Subject: Duke Power Company LLC d/b/a
Duke Energy Carolinas, LLC (Duke)
McGuire Nuclear Station, Units 1 and 2
Docket Nos. 50-369 and 50-370

License Amendment Request for Selective
Implementation of the Alternative Source
Term and Revision to Technical Specification
3.9.4, Containment Penetrations.
Response to Request for Additional
Information

ATTACHMENT 1

McGuire Nuclear Station Wind Roses

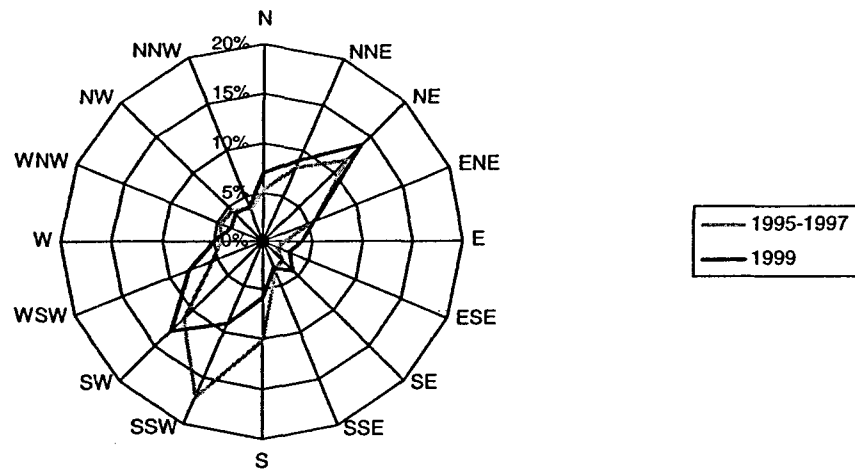
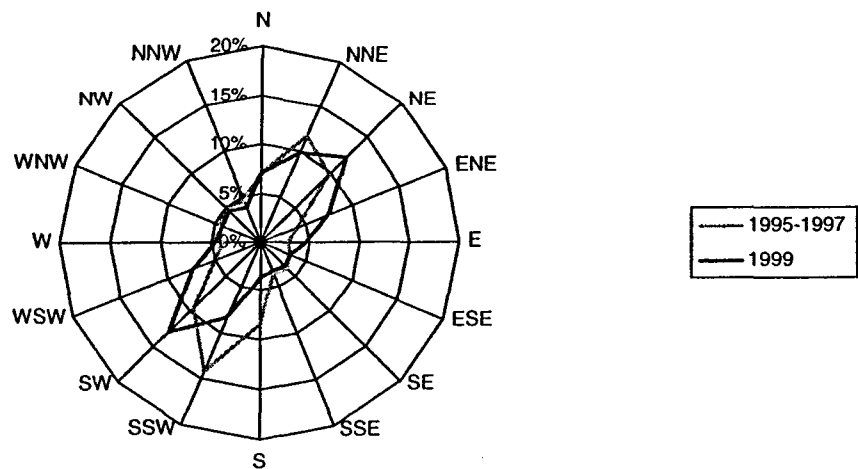
New control room atmospheric dispersion factors (χ/Q values) were calculated in support of this license amendment request using onsite meteorological data for the period 1995-1999. Section 2.3.3.5 of the McGuire Nuclear Station (MNS) updated final safety analysis report states that a new meteorological tower and new meteorological instrumentation became operational in September 1998. Wind roses comparing wind direction frequency distributions between the 1995-1997 and the 1999 data are presented in Exhibit A.¹ These wind roses show considerable discrepancies for the following wind direction sectors:

Period of Record	Wind Direction Sector - Lower Level				
	NE	S	SSW	SW	WSW
1995-1997	11.6%	10.1%	17.0%	10.9%	5.4%
1999	13.7%	5.7%	9.1%	12.8%	7.9%

Period of Record	Wind Direction Sector - Upper Level				
	NE	S	SSW	SW	WSW
1995-1997	9.6%	8.3%	14.2%	9.3%	4.9%

- 1a. Please explain what might have caused the discrepancies in wind direction and stability class frequency distributions between the 1995-1997 and 1999 data sets (e.g., changes in tower structure, tower location, sensor elevation, boom orientation, vegetation growth, instrumentation, data processing, etc). Please also explain which of these two data sets is considered the most representative of current site conditions.

Data from the current meteorological tower (operational on September 1, 1998) is considered more representative of ambient conditions at the plant site. The current meteorological tower has an open exposure in all directions and fewer occurrences of extreme stability classes (A and G) are observed.

Wind directions are noted to have shifted slightly between the earlier data and data from the current tower location. This is expected, due to the previous location being at a lower elevation above sea level, below the dam. Wind directions typically turn clockwise, veering with higher elevations or heights above ground. Thus, it is expected that the 10 m winds would show more of a clockwise shift at the current tower location than at the previous location. Also, the 60 m level wind direction would be expected to shift clockwise more than the 40 m level wind direction from the old tower.

McGuire Nuclear Station Stability Class Frequency Distributions

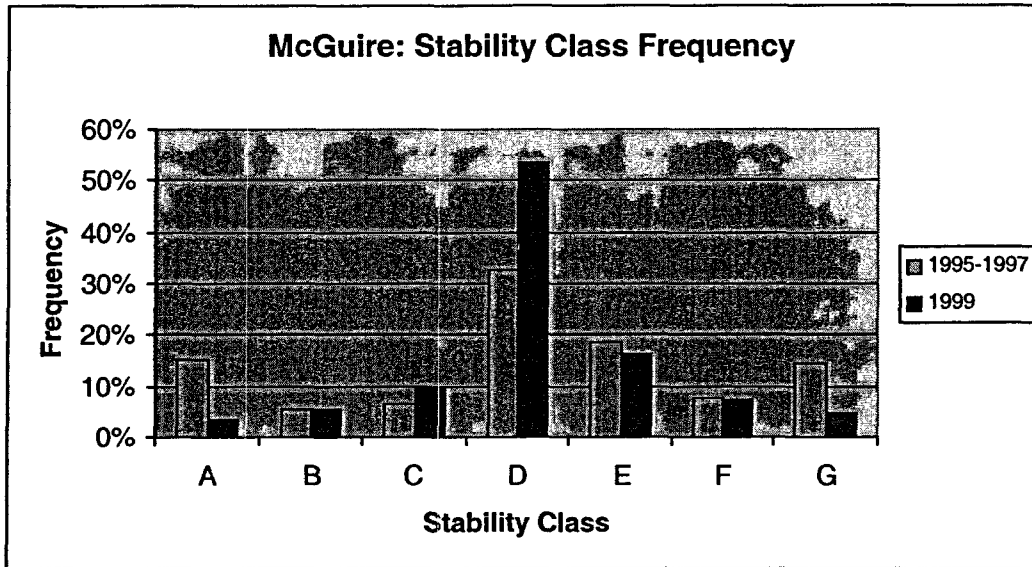
Similarly, stability class frequency distributions comparing the 1995-1997 data set and the 1999 data set are presented in Exhibit B. These frequency distributions show considerable discrepancies for the following stability classes:

Period of Record	Stability Class		
	A	D	G
1995-1997	15.4%	32.6%	14.3%
1999	3.3%	53.6%	4.6%

These earlier towers were not like the standard meteorological towers of today, and were not designed to minimize effects on the winds. The previous tower location would also have been subject to mechanical turbulence from the wakes of nearby buildings. The greater frequency of stability classes A and G in the older data is attributable to local terrain and building effects on temperatures. Nighttime drainage flow of cooler air down into the river valley would produce more hours of stability class G, while daytime heating of the buildings in proximity to the old towers would result in more hours of stability class A.

The current tower is located approximately 1350 ft NNE of station center, with base elevation of 767.1 ft msl. It is a standard meteorological tower, designed as a more open and aerodynamic structure, with instrumentation at the 10 m and 60 m levels above ground. The location of the current tower has an open exposure in all directions. The increased vertical separation distance between the upper and lower level temperatures provides a better categorization of the temperature differences by which stability class can be determined.
